<b>Docket Number:</b>	17-AAER-15
<b>Project Title:</b>	Appliance Efficiency Standards Rulemaking for Computers and Light-Emitting Diode Lamps
<b>TN #:</b>	221131
<b>Document Title:</b>	Presentation - ITI & TechNet Concerns CEC ComputersDisplays (August 10, 2016)
<b>Description:</b>	Document relied upon. Information Technology Industry Council (ITI) and Technology Network (TechNet), ITI & Technet Concerns CEC Computers/Displays (August 10, 2016). Powerpoint presentation.
<b>Filer:</b>	Patrick Saxton
<b>Organization:</b>	Technology Industry Council (ITI) and Technology Network (TechNet)
<b>Submitter Role:</b>	Public
<b>Submission Date:</b>	9/12/2017 3:17:59 PM
<b>Docketed Date:</b>	9/12/2017

# ITI & TechNet Concerns CEC Computers/Displays **August 10, 2016**

## Traditional packaging example

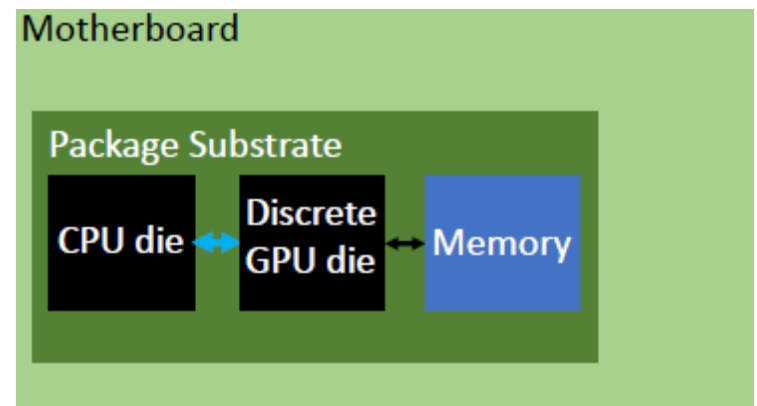
- Limits future dGPU and computer designs
  - Restricts future packaging options in CA; prevents multi-chip packaging, and system on chip designs using a CPU and discrete GPU
  - Example: 15-day language limits dGPU adders to traditional packaging option
    - dGPUs in examples shown below have similar performance & power

15-day language: allowed on CA.  
market

45-day language: allowed on CA.  
market

15-day language: cannot be placed on CA.  
market

45-day language; allowed on Ca. market

- Allow same adder approach as used for current dGPU adders (given similar dGPU power consumption in idle)
- Use definition dGPUs that's in 45-day language
